IN THE DRAWINGS:

ANNOTATED SHEET SHOWING CHANGES

Fig. 1

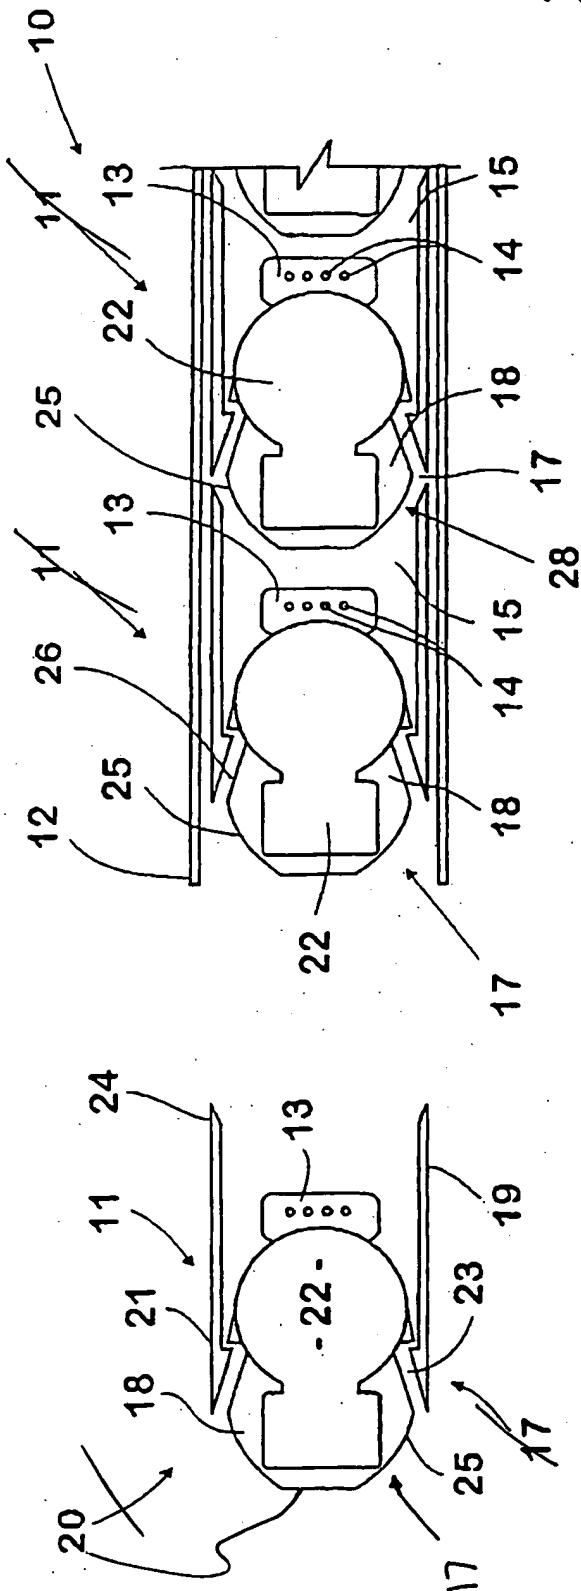
Subject to the approval of the Examiner, it is respectfully requested that Figs. 1-5 be amended to correct certain reference numeral errors and to improve clarity. The proposed changes are supported by the originally-filed specification and are indicated in red on the attached copy of Figs. 1-5. These drawing changes were approved by the Examiner in the parent application, Application No. 09/958,465. Additionally, it is respectfully requested that Figs. 1-11 be amended to delete "SUBSTITUTE SHEET (RULE 26)" from the footer and other PCT information from the header of the drawings.

If approved, please replace the informal drawings in this application with the 7 replacement sheets of formal drawings filed herewith (Figs. 1-11), which incorporates the requested changes. If the formal drawings for any reason are not in full compliance with the pertinent statutes and regulations, please so advise the undersigned.
